SILVERTON PLANNING COMMISSION  
**REGULAR MEETING**  
SILVERTON COMMUNITY CENTER  
421 S. WATER STREET  
**MAY 12, 2015 - 7:00 PM**

**RE:** Revised Site Design, CU-15-01

FILE NO. CU-15-01

**PROPOSED DEVELOPMENT ACTION:** CONDITIONAL USE APPLICATION TO CONSTRUCT A 390 SQUARE FOOT COMMERCIAL BUILDING WITH A DRIVE-THROUGH AT 705 McCLAIN STREET. THE PROPOSED USE OF THE BUILDING WILL BE SALES-ORIENTED RETAIL SALES AND SERVICE AND WILL BE A DUTCH BROTHERS.

### Revised Site Plan

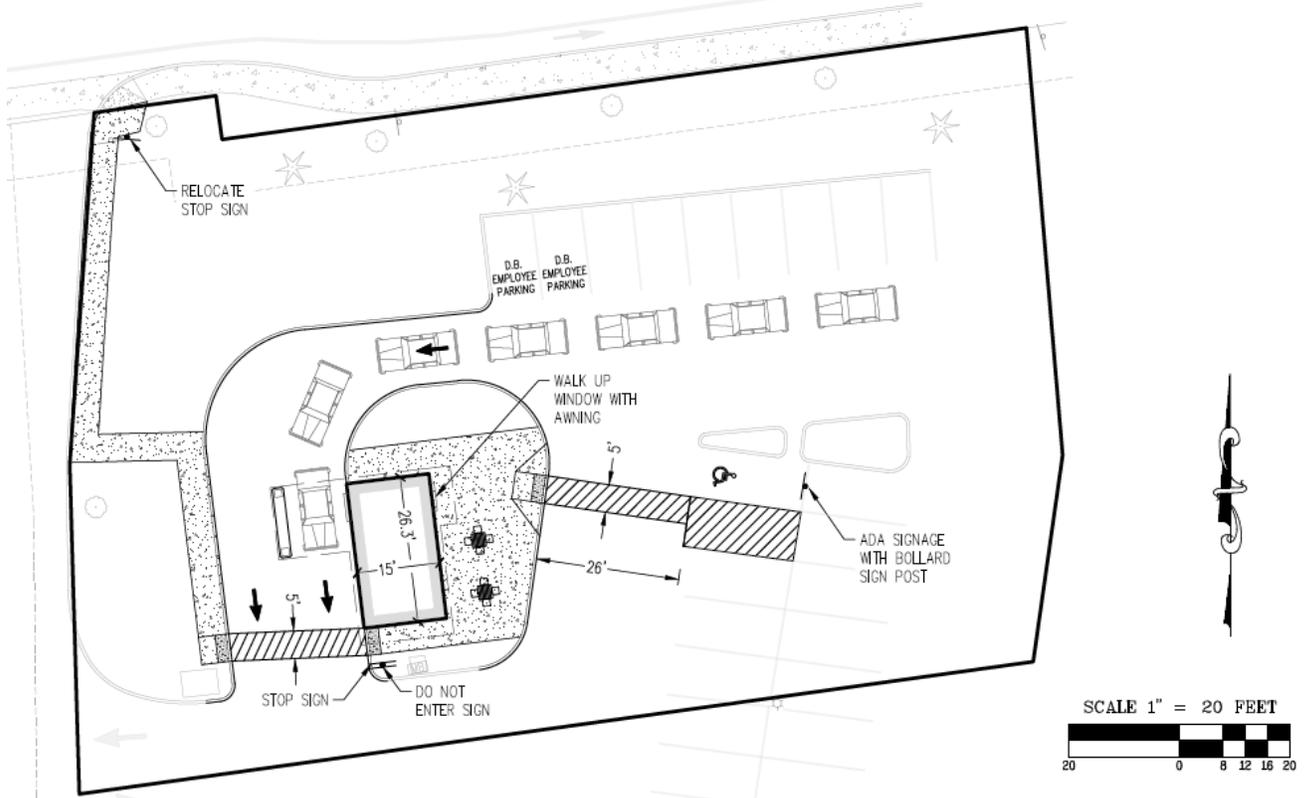
The revised site layout was prepared to accommodate 7 cars without blocking the entryway into the site. The applicant prepared two alternates that achieve this with one directing the cars to the south to drive around the parking lot and queue in the most northern parking lot aisle. This option provides the most assurance that the entry drive aisle will not be blocked, but it does rely on customers following signage for out of direction travel to enter the queue. This option also would temporarily block 6 of the northern parking stalls during the 7 car peak. However, it has been observed that these stalls are typically used by employees of other businesses in the plaza and have a low turnover rate which reduces the amount of actual conflicts. In addition, these stalls are typically empty during the AM peak. Adequate parking in the AM peak exists on site to serve the customers that would choose the walkup window when the drive thru queue starts to backup. There are 15 parking spaces adjacent to the walkup window that would be utilized by walkup customers. The main other AM business in the plaza is the gym in the opposite corner, with most gym users parking in the southeast corner of the site. The site has been observed to have 11 cars parked in the lot at around 8:00 a.m.

This may either equate to fewer cars in the PM queue or an increase in the amount of overall customers in the PM time period. A five car queue in the PM with this revised design would temporarily impact one of the non-Dutch Bro employee parking spaces in the northern parking bay. Cars parked to use the walkup window would likely have a relatively fast turn over compared to some of the other businesses in the plaza. The parking lot is utilized fairly heavily in the PM time period. The site has 85 total spaces and was observed to have 65 occupied spaces and 20 spaces (including 4 ADA spaces) open at 5:20 p.m. on May 6<sup>th</sup>. This equates to an occupancy rate of 76.5% with 23.5% spaces free. Donald Shoup, the author of the 2005 book *The High Cost of Free Parking*, identified that an occupancy rate of 85% is the most efficient use of public parking. This revised layout addresses the previous concerns of the queue blocking the entryway into the site but it does rely on customers following out of direction travel directions to enter the queue.

This alternate revised layout addresses the previous concerns of the queue blocking the entryway into the site and provides the most direct access to the uses but does not have as much excess stacking depth as the other revised design. Given the uncertainty of people following signage for out of direction travel and lack of enforcement method, Staff recommends this alternate design as the preferred design. Based on the revised design, the stacking area is sufficient to ensure that the entry drive is not obstructed. Traffic will be able to enter and exit the site under the proposed design. The standard is met.

### Revised Alternate Site Plan

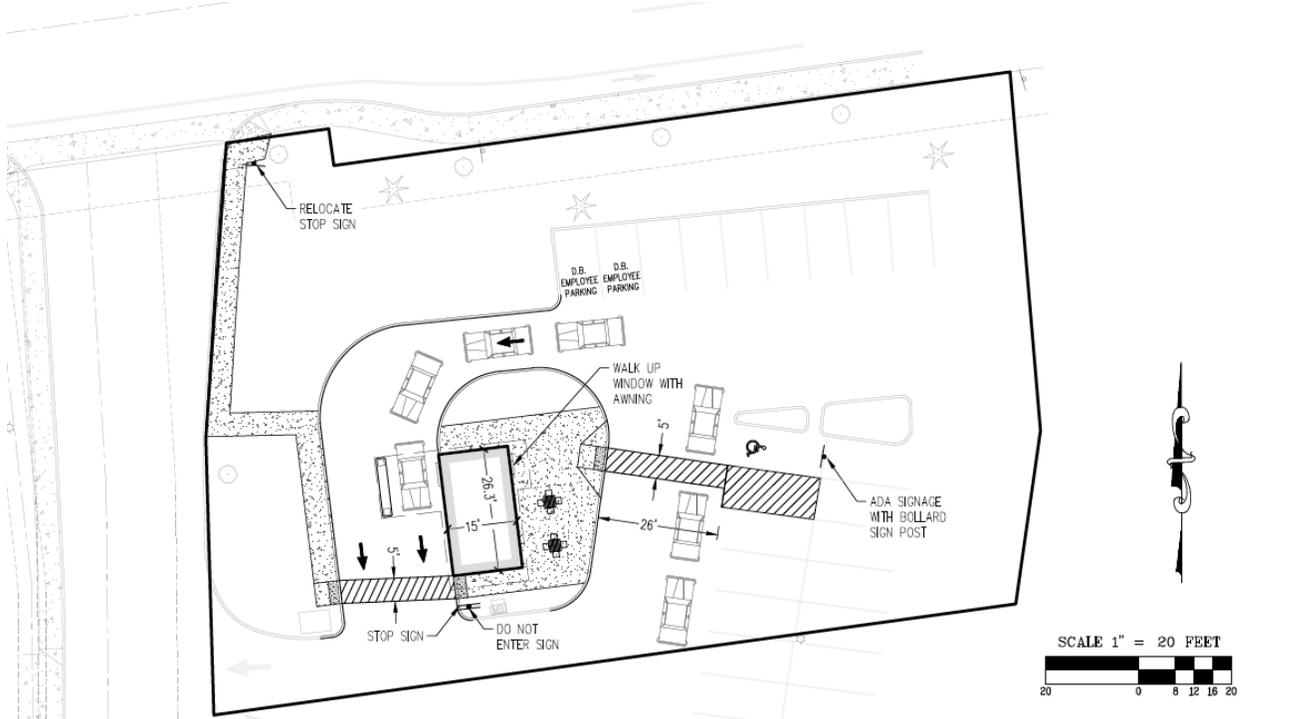
The applicant also provided an alternate revised design where cars enter the queue in the most direct manner. In this revised design the cars enter the site and turn left to enter the queue, which is the most direct route to the queue. No signage or out of direction travel is required in this design.

This option keeps the site drive aisle clear under the 7 car queue but may temporarily block the southern drive aisle with an 8 or 9 car queue, pending actual queue length. It should be noted that an 8 car queue was not observed at the Dallas location. The entryway into the site is anticipated to remain clear with this design. This option also would temporarily block 4 of the adjacent parking stalls during the 7 car peak. However, it has been observed that these are typically empty during the AM period. Adequate parking in the AM peak exists on site to serve the customers that would choose the walkup window when the drive thru queue starts to backup. There are 15 parking spaces adjacent to the walkup window that would be utilized by walkup customers. The PM queue of 5 cars is accommodated with the possibility of the ADA space being temporarily blocked.
